25 WEBSTER ST. PHASE 2

SB# 06-22

STAFF REPORT

PURPOSE OF PLAN: To subdivide Map 181 Lot 001-001 into four (4) residential building lots served by a common driveway and to relocate the lot line of Map 181 Lot 001-000.

SHEET: 2 of 14

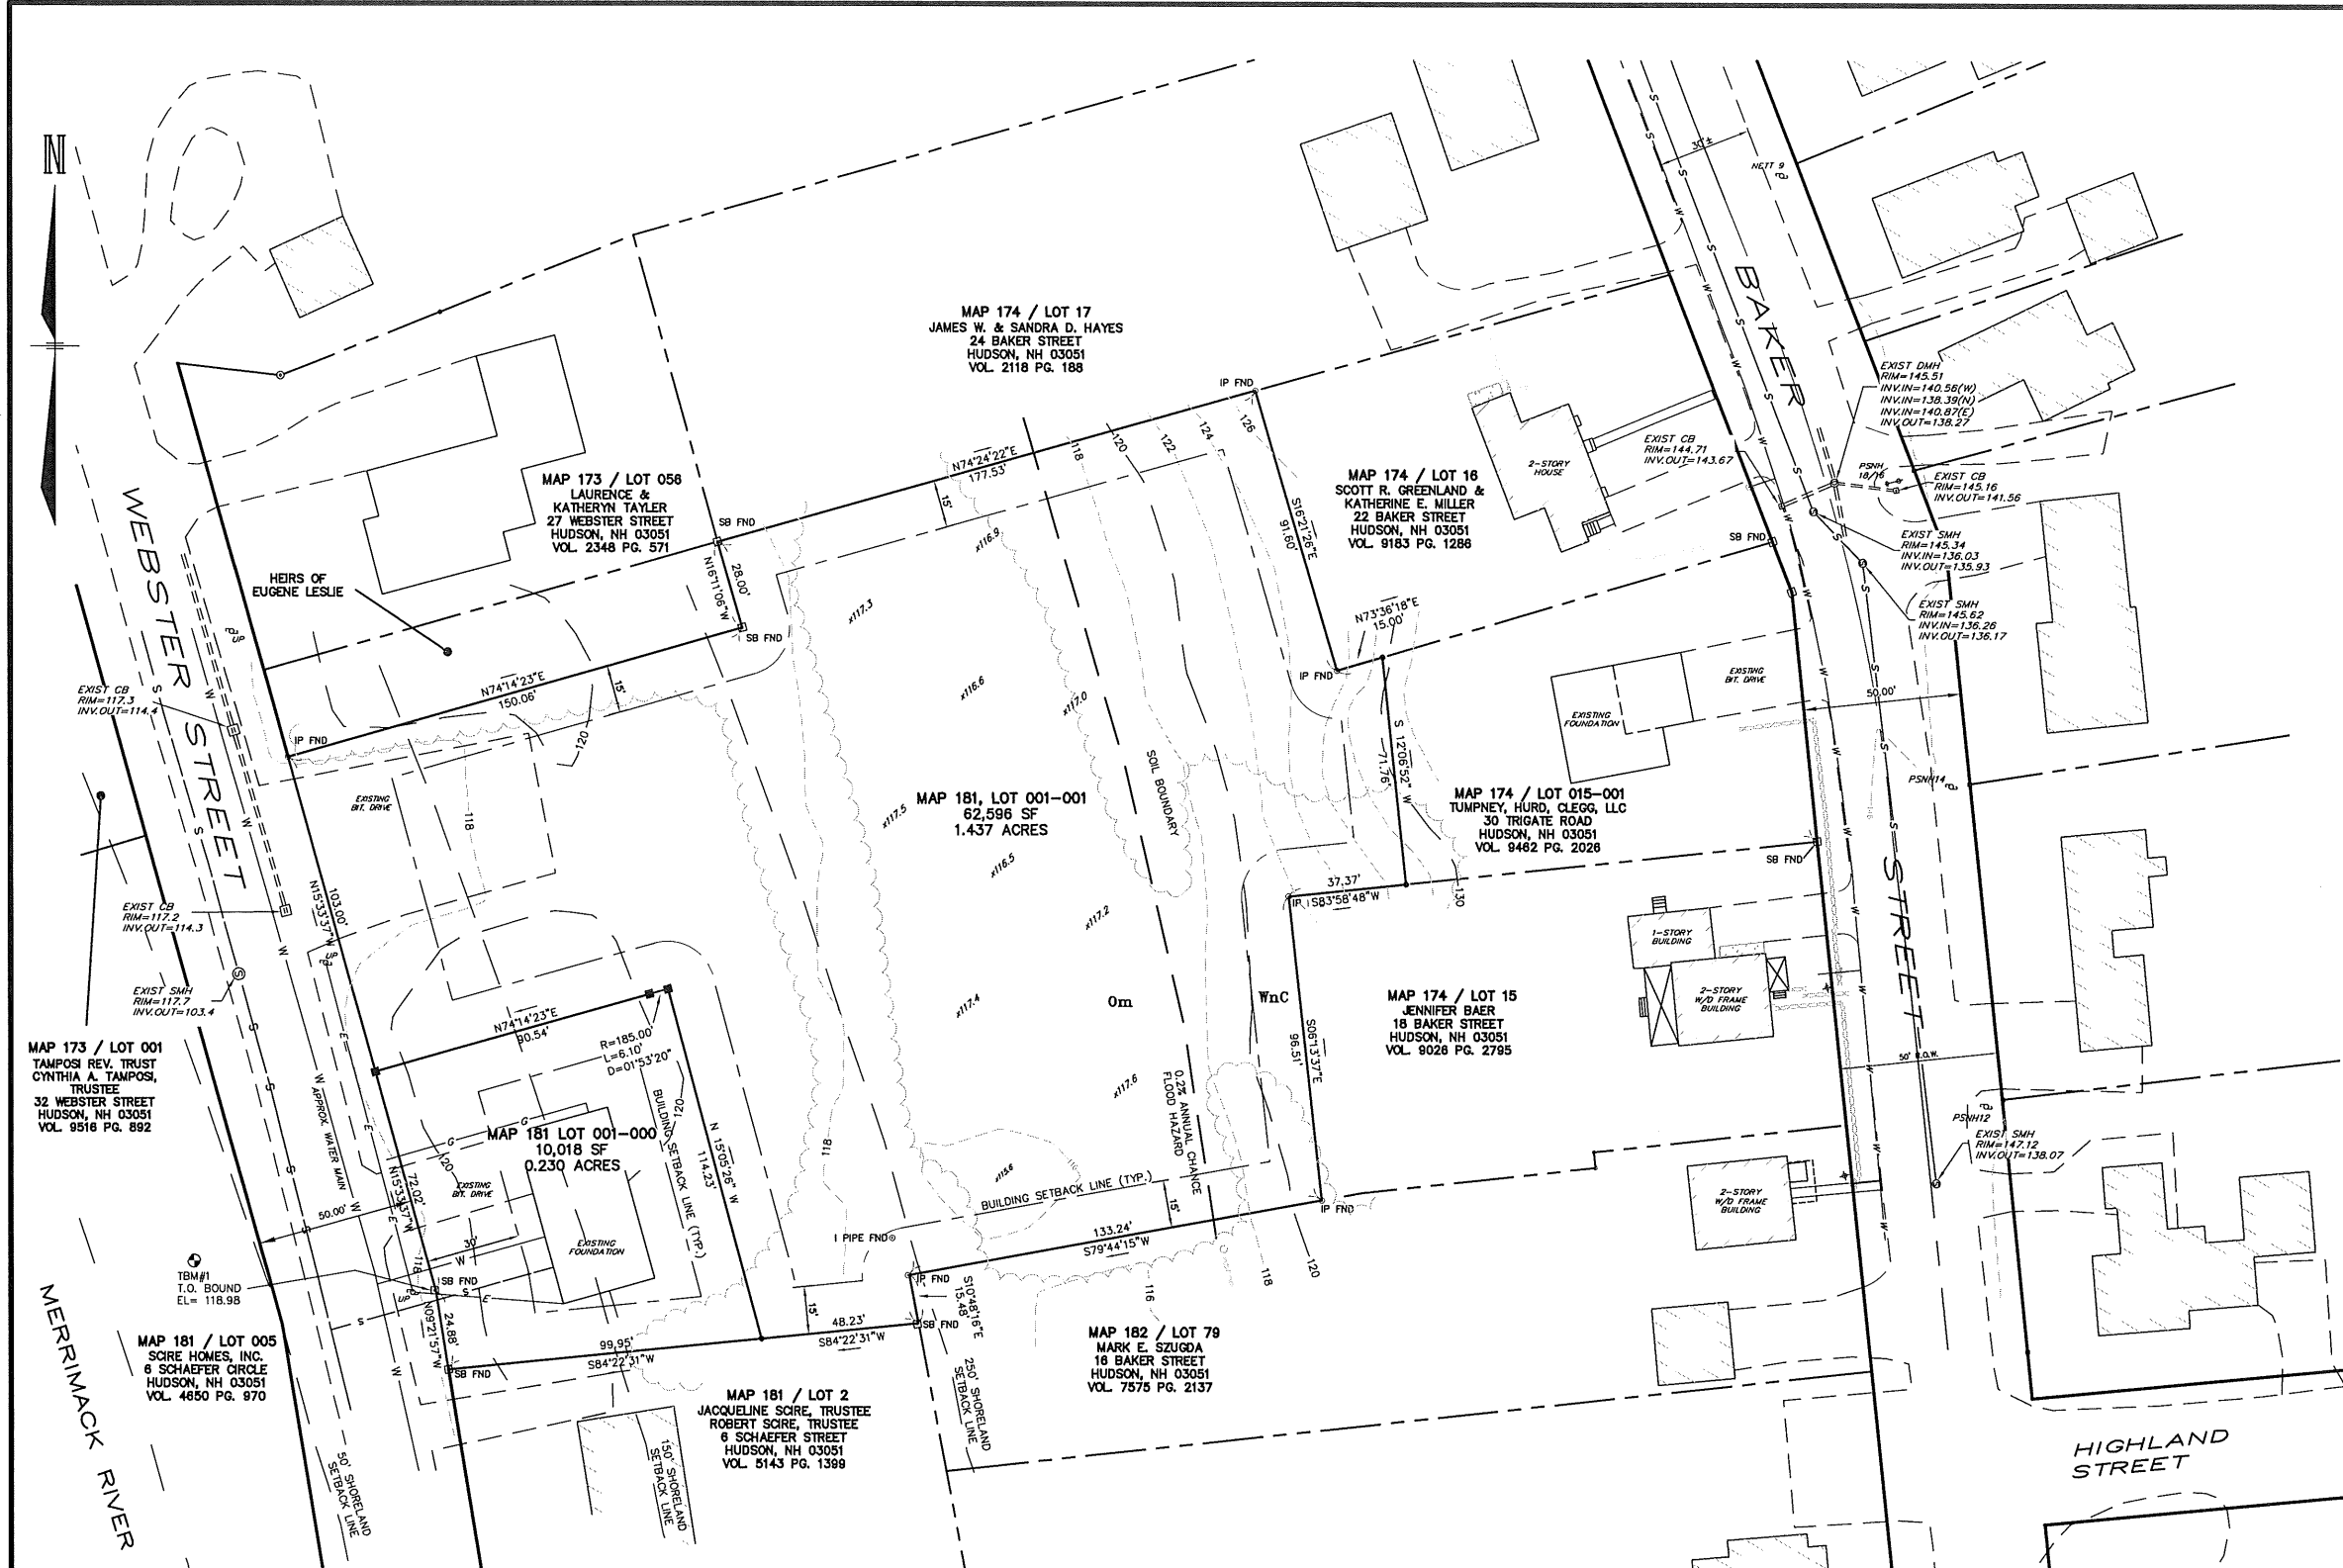
- e. HR 276-11.1.B.(16). The applicant has not included information on driveways and travel ways within 200 feet of the site. The current plan only shows information approximately between 50 and 150 feet from the site.

- e. HR 276-11.1.B.(16). The applicant has not included information on driveways and travel ways within 200 feet of the site. The current plan only shows information approximately between 50 and 150 feet from the site. **An overview plan, sheet 2, has been added to the plan set depicting Town GIS mapping of the vicinity.**

SHEET: 4 of 14

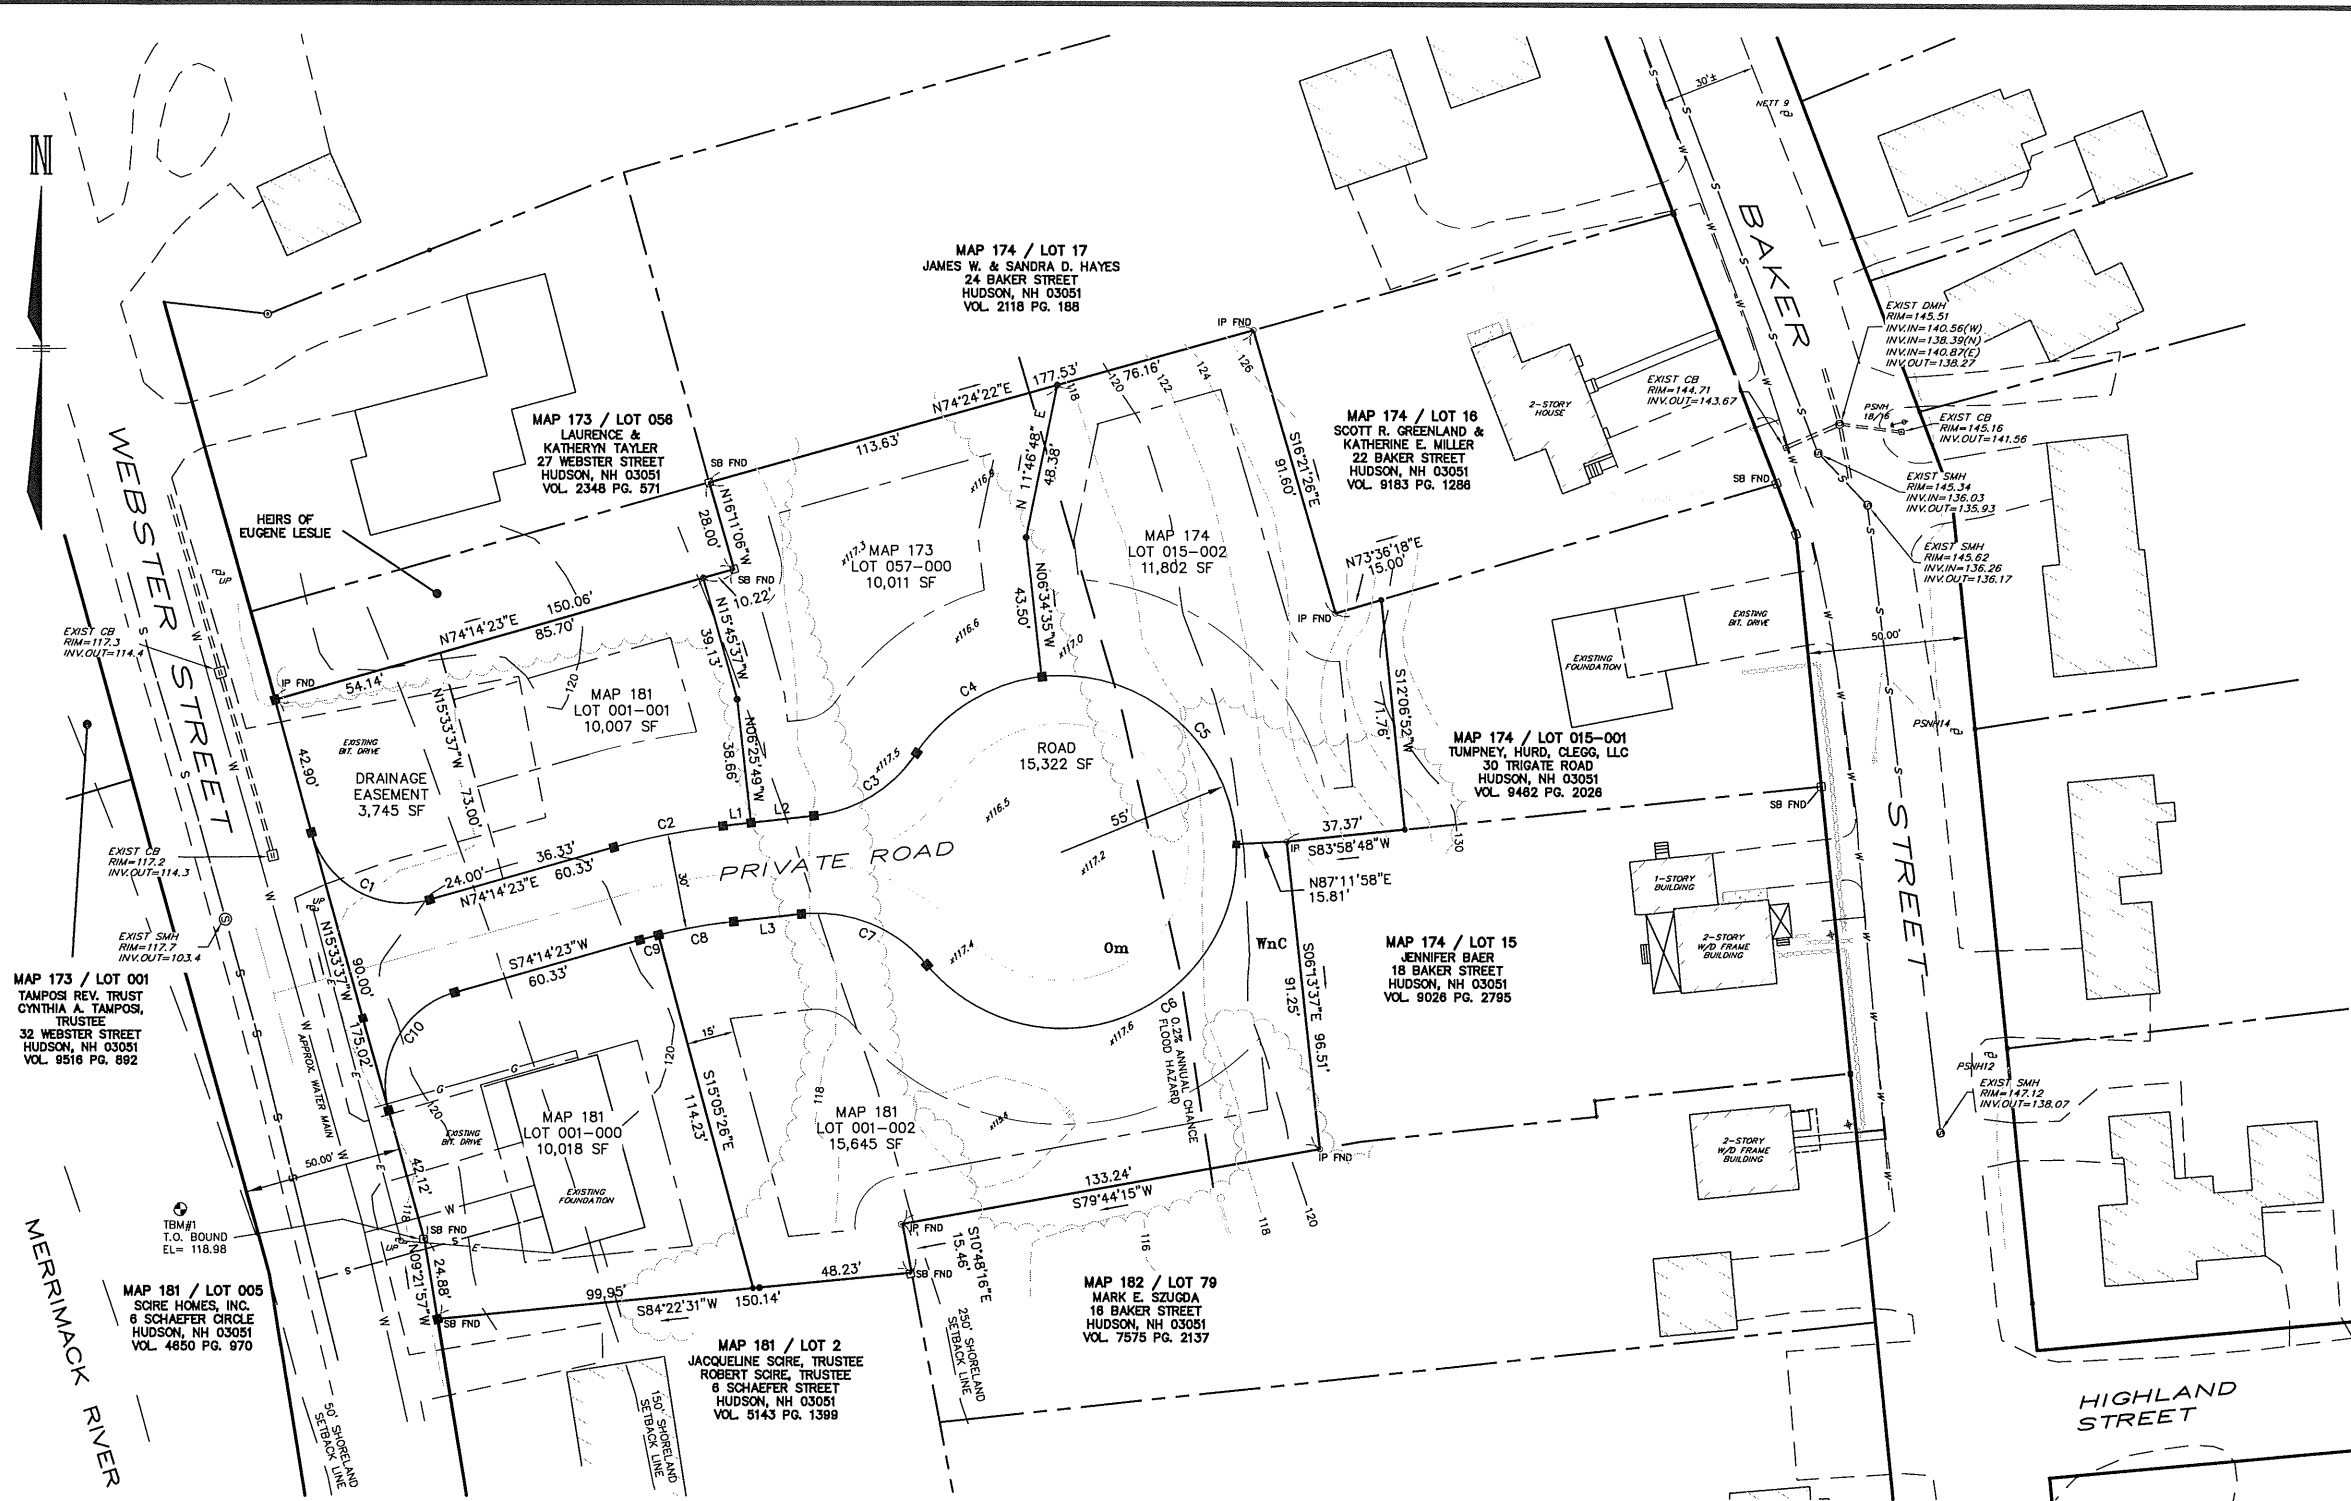
- a. Hudson Regulation HR 276-11.1.B.(4). & 289-27.A.(3). The applicant should add the approval block to all sheets of the plan set per the Regulations.
- b. HR 276-11.1.B.(6). The owner's signature was not provided on the plan set; however, a space was provided for their future signatures.
- c. HR 276-11.1.B.(13). The applicant has not shown any sign locations or details on the plan set other than traffic signs.
- d. HR 276-11.1.B.(14). The applicant has not shown any lighting on the plan set. The applicant should confirm if any lighting is proposed and provide locations and details, or add the required note if lighting is not proposed.

- c. HR 276-11.1.B.(13). The applicant has not shown any sign locations or details on the plan set other than traffic signs. **Note number 10 has been added to sheet 4.**

- d. HR 276-11.1.B.(14). The applicant has not shown any lighting on the plan set. The applicant should confirm if any lighting is proposed and provide locations and details, or add the required note if lighting is not proposed. **Note number 11 has been added to sheet 4.**

5. Zoning (HR 334)
- a. HR 334-14 and HR 276-11.1.B.(20). The applicant has not noted the maximum proposed building heights on the plan set. The applicant should note the maximum building height of 38 feet on the plan set. **Note 13 has been added to sheet 4.**

- b. HR 334-20. The site is located in the Town Residence (TR) District. The applicant should provide a formal use note confirming that single family homes are the proposed use. **Note 1 on sheet 4 has been revised to specify that the lots are intended for single-family homes.**

SHEET: 6 of 14

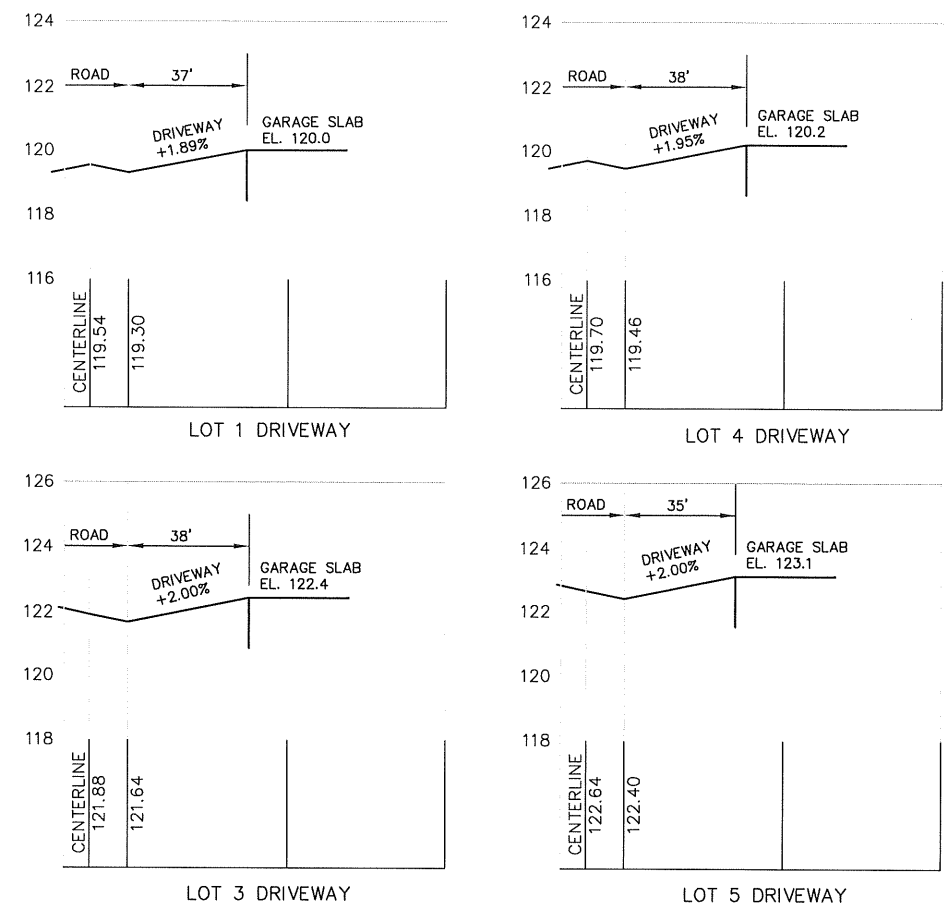
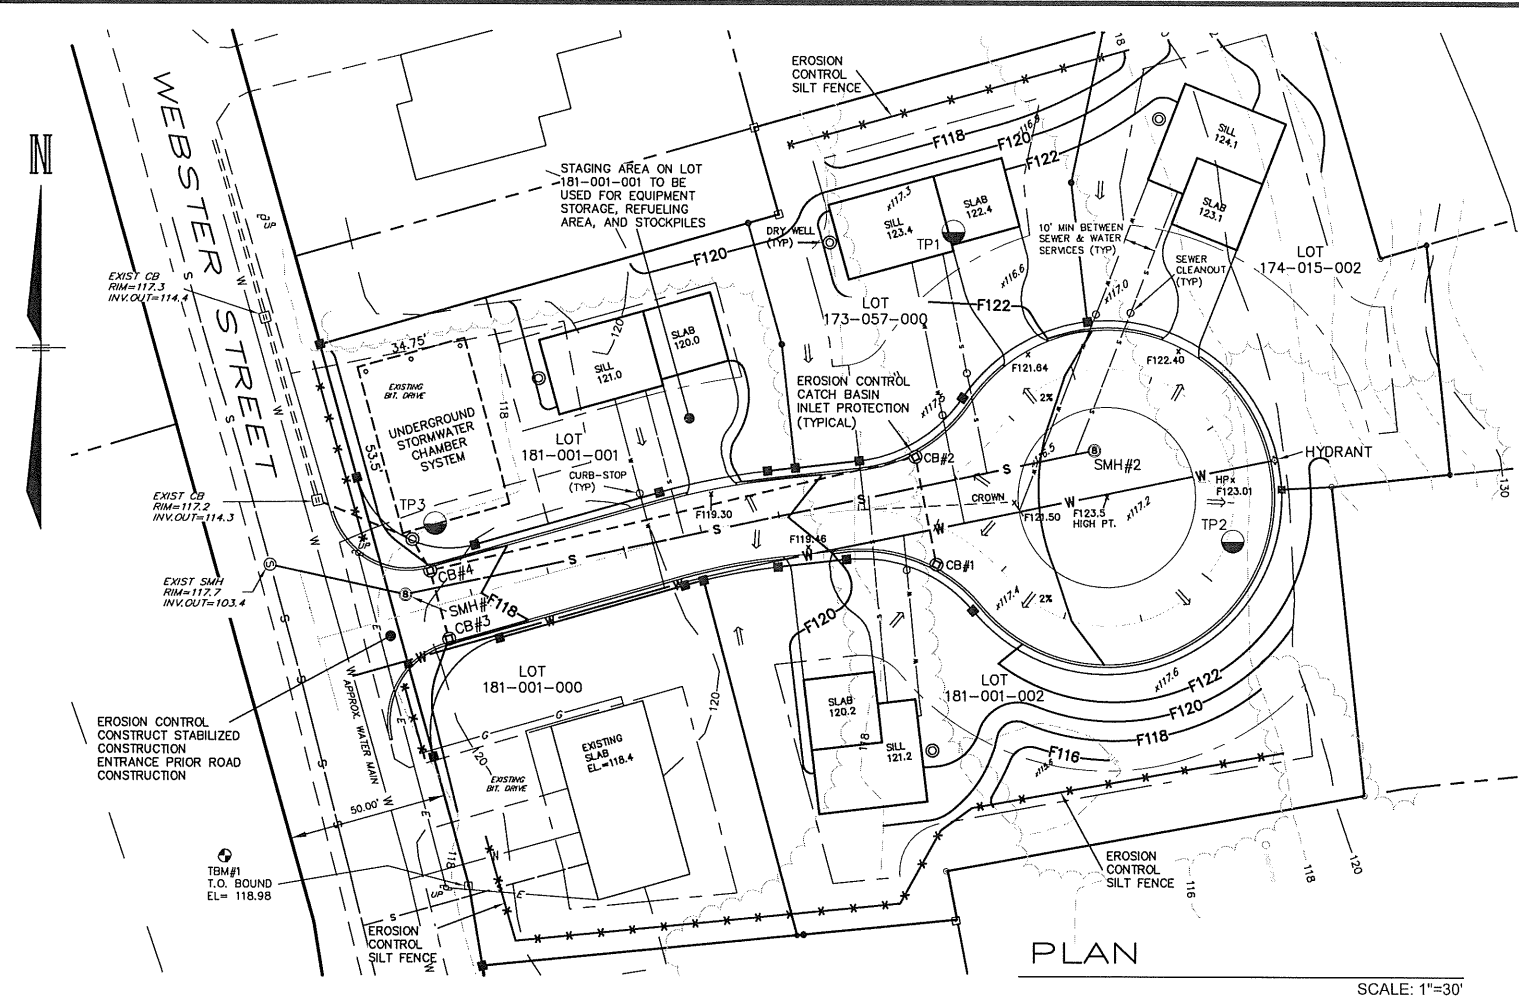
- c. HR 289-18.B.(5). The applicant should add dead-end and stop sign locations to the plan set. Details have been provided.
- d. The applicant should show a stop bar location and detail on the plan set.

- e. HR 289-18.C.(1). The applicant should show horizontal curve information on the plan set.
- f. HR 289-18.R.(b). & 289-28.G. The applicant has requested a waiver from providing sidewalks. We note the applicant should remove the sidewalk from the Typical Individual Lot detail on the plan set.

- k. The applicant should label the curb curve radii on the plan set.
- l. The applicant has shown the existing utility pole on the north side of the proposed roadway projecting into the road beyond the proposed curb line. Either the curb line should be adjusted so that the pole is behind the curb or the pole should be relocated. The applicant should consult with the owner of the utility pole to verify the minimum dimension behind curbing that is required to prevent damage from plows, etc.

- c. HR 289-18.B.(5). The applicant should add dead-end and stop sign locations to the plan set. Details have been provided. **A general roadway plan, sheet 6, has been added to the set and the sign locations have been added to this sheet.**

- d. The applicant should show a stop bar location and detail on the plan set. **This has been added to sheet 6.**
 - e. HR 289-18.C.(1). The applicant should show horizontal curve information on the plan set. **This has been added to sheet 6.**

- k. The applicant should label the curb curve radii on the plan set. **The radii has been added to the general roadway plan, sheet 6.**
 - l. The applicant has shown the existing utility pole on the north side of the proposed roadway projecting into the road beyond the proposed curb line. Either the curb line should be adjusted so that the pole is behind the curb or the pole should be relocated. The applicant should consult with the owner of the utility pole to verify the minimum dimension behind curbing that is required to prevent damage from plows, etc. **A note has been added to the plan to relocate the pole.**
